All parts and materials that are required for the TN8017 are included in order no. 45005075, "material for TN8017", see working instruction no. 1 for TN8017.

Issued: January 2011 Author: J.B. Wassenaar

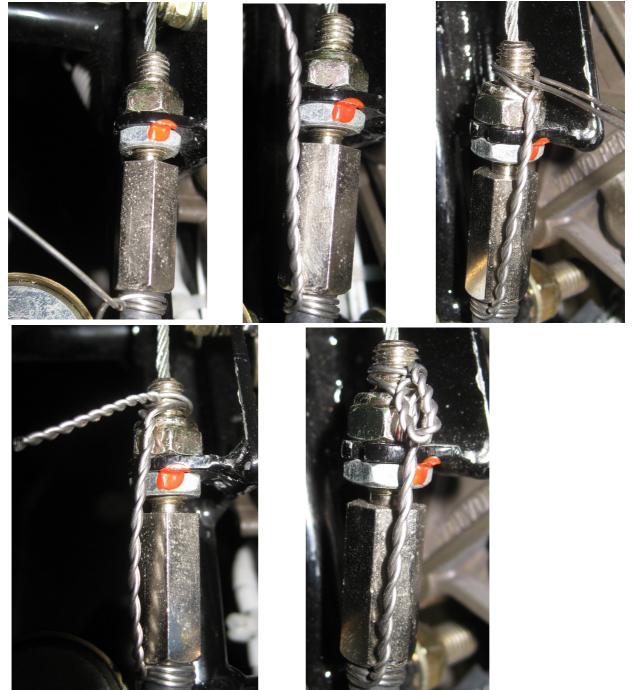
- 1. Extend power plant, using manual switch (ignition off!).
- 2. Check the correct setting of the decompression valves and correct if necessary, see maintenance manual paragraph 1.9.7.
- 3. The decompression handle in the cockpit should be in the "closed" position.
- 4. The Bowden outer of the decompression control must be secured to the adjusting screw, using lock wire, see pictures below. This secures that the Bowden outer cannot slip out of the adjusting screw, during extension or retraction of the power plant. Hence this prevents jamming of the Bowden outer which may cause that the decompression valve don'tagain close.
- 5. Check again if the Bowden outer slips out of the adjustment screw during extension and retraction of the power plant.
